Service Note		
Product	Description:	Service note no.
BM5A BM5A Comp. BM6A MK II BM12A	Bad connection in signal cable	SNo_T095

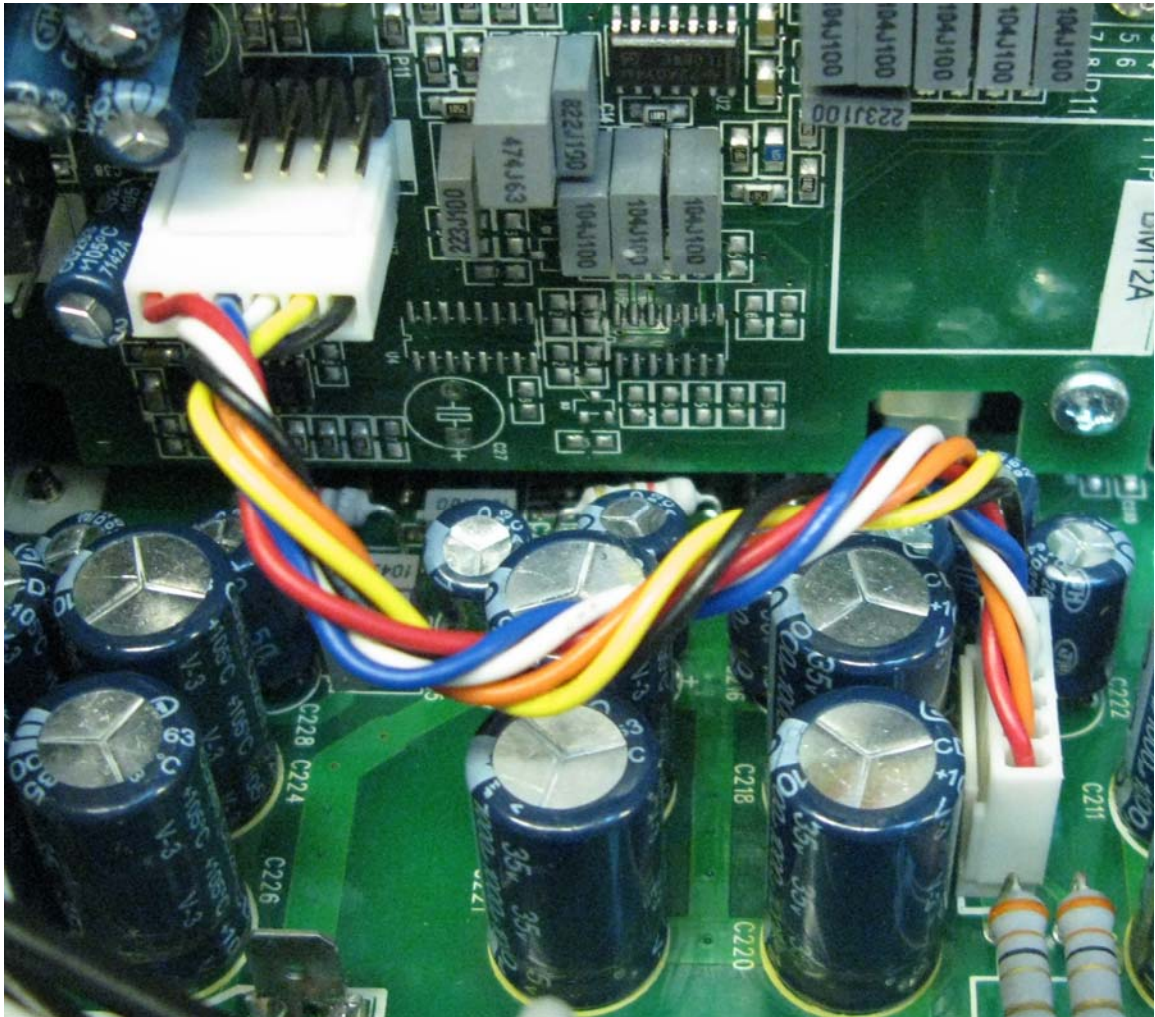
Reason for note: Recently it has been discovered that there can be a bad connection in the signal cable going from the input board to the amp board.

Actions: Wires shall be soldered directly in the PCB's.
